June 10, 2010

Re: Comments on Tentative Order No. R2-2010-XXXX, NPDES Permit
No. CA0029122
GWF Power Systems, L.P. – Nichols Road Plant (Site V)

**Sacramento Area Precipitation- Jan. 1997
(RMP sample collected on Jan. 29, 1997)**

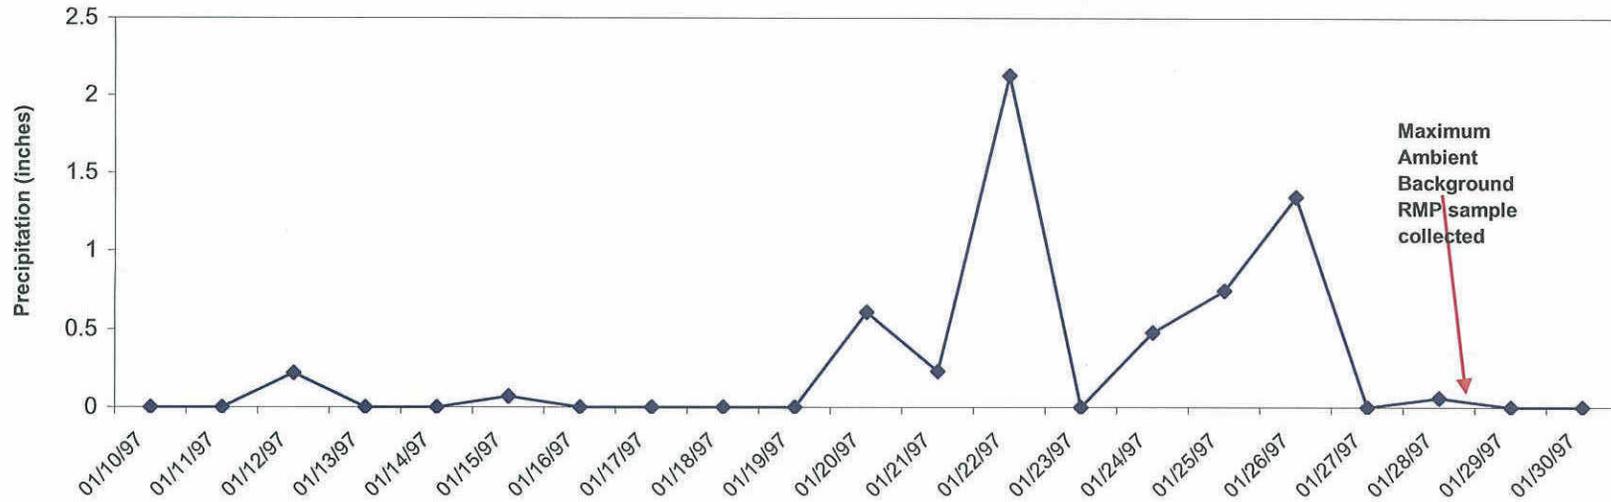
The maximum Sacramento River RMP concentrations for lead, copper and zinc (as well as arsenic, cadmium, mercury, nickel and TSS) are from the same sample collection date – January 29, 1997. The next-highest RMP values were obtained from samples collected on February 4, 1998. GWF has obtained historical precipitation records for the Sacramento area, which demonstrate that significant storms occurred immediately preceding these two RMP sampling dates. (Exhibit 2; Sacramento Area Precipitation Records). It is also noteworthy that these two sampling events are more than 12 years old and can hardly be considered representative of current ambient conditions. GWF believes these RMP values are “*not representative of the ambient receiving water column*” and the Regional

Board should exercise its discretion, as provided in the SIP, to omit these values when calculating the effluent limits.

Therefore, GWF requests that the next-highest Sacramento River RMP values be used to calculate the effluent limitations, namely: lead = 1.508 µg/L, copper = 5.823 µg/L and zinc = 11.489 µg/L. Use of these data result in the following effluent limits:
